Major Permit to Alter Case Report

Filing Date: August 12, 2015
Case No.: 2015-008484PTA
Project Address: 856 MARKET STREET
Conservation District: Kearny-Market-Mason-Sutter
Building Category: Category V (Unrated)
Zoning: C-3-R (Downtown Retail) District
80-130-F Height and Bulk District
Block/Lot: 0329 / 004
Applicant: Chuck Bloszies
228 Grant Avenue, 6th Floor
San Francisco, CA 94108
Staff Contact: Pilar LaValley - (415) 575-9084
pilar.lavalley@sfgov.org
Reviewed By: Tim Frye - (415) 575-6822
tim.frye@sfgov.org

RE: **Meeting Notes from Review and Comment at the
December 2 ARC-HPC Hearing for 856 Market Street**

PERFORATED METAL MESH DETAILS

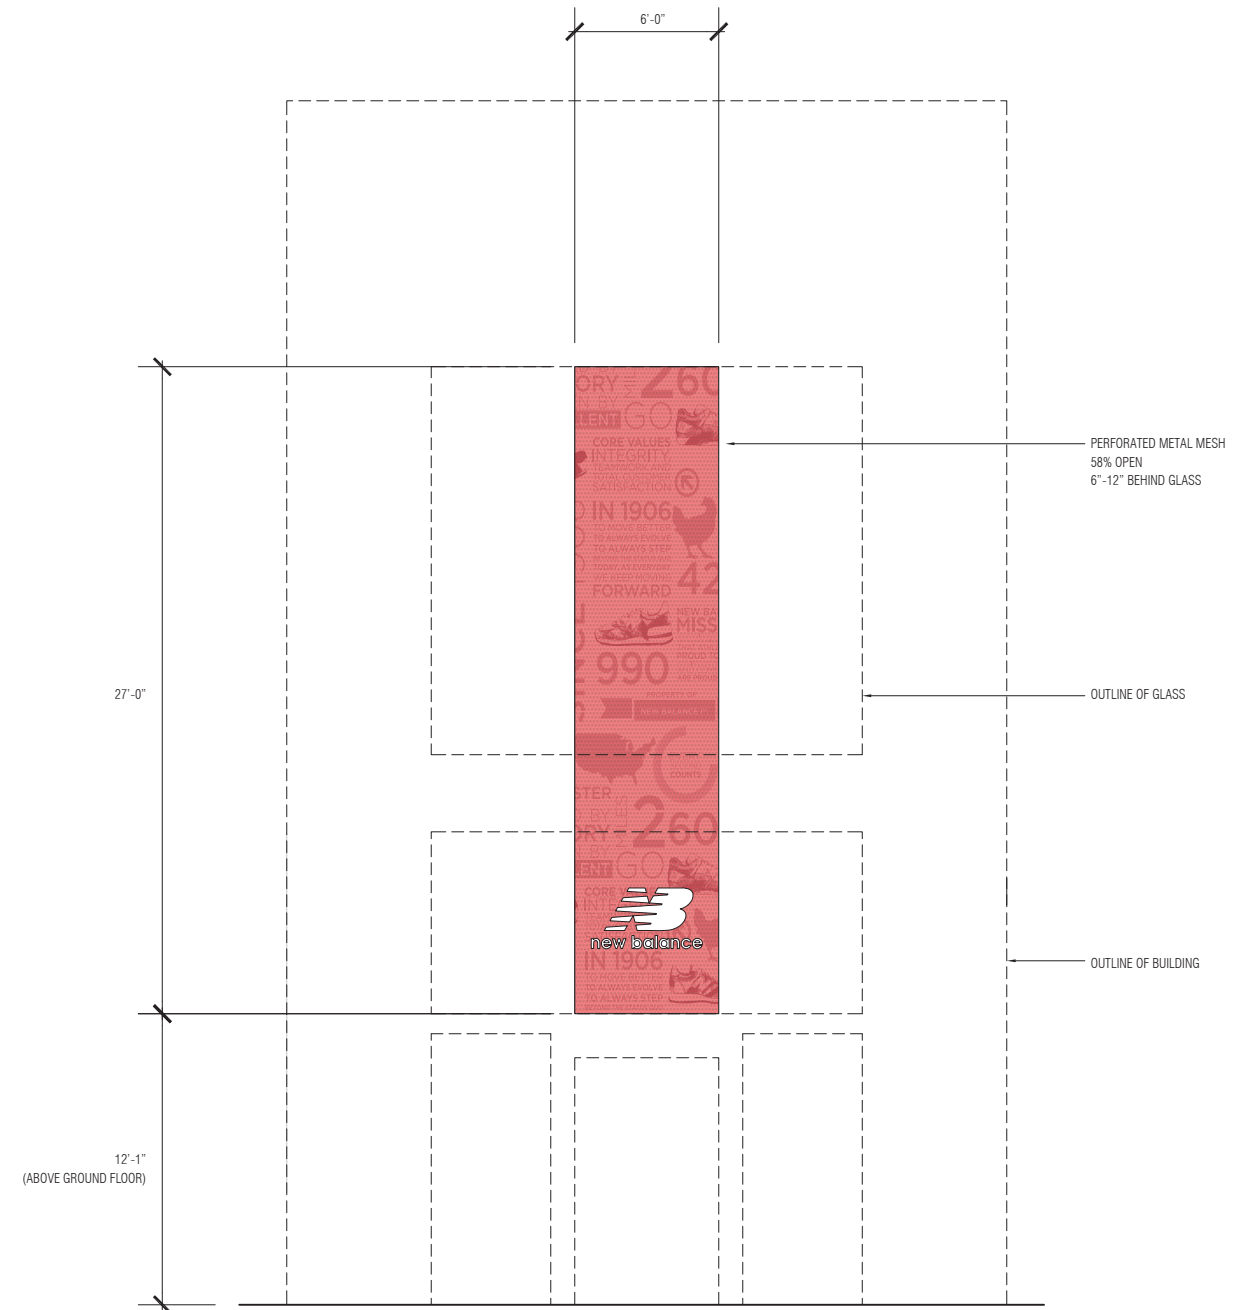
A perforated red metal screen is proposed to be installed behind the center window, spanning the height of the window openings. This screen would be set approximately 12 inches behind the window glazing; the proposed wall sign will be mounted to the face of the screen. As this screen has not yet been fully designed, we recommend the following condition of approval to ensure that this installation meets transparency requirements for the District:

3. *That shop drawings and/or material sample of the proposed perforated metal screen be provided to Preservation staff for review and approval prior to approval of the Building Permit or Architectural Addendum.*
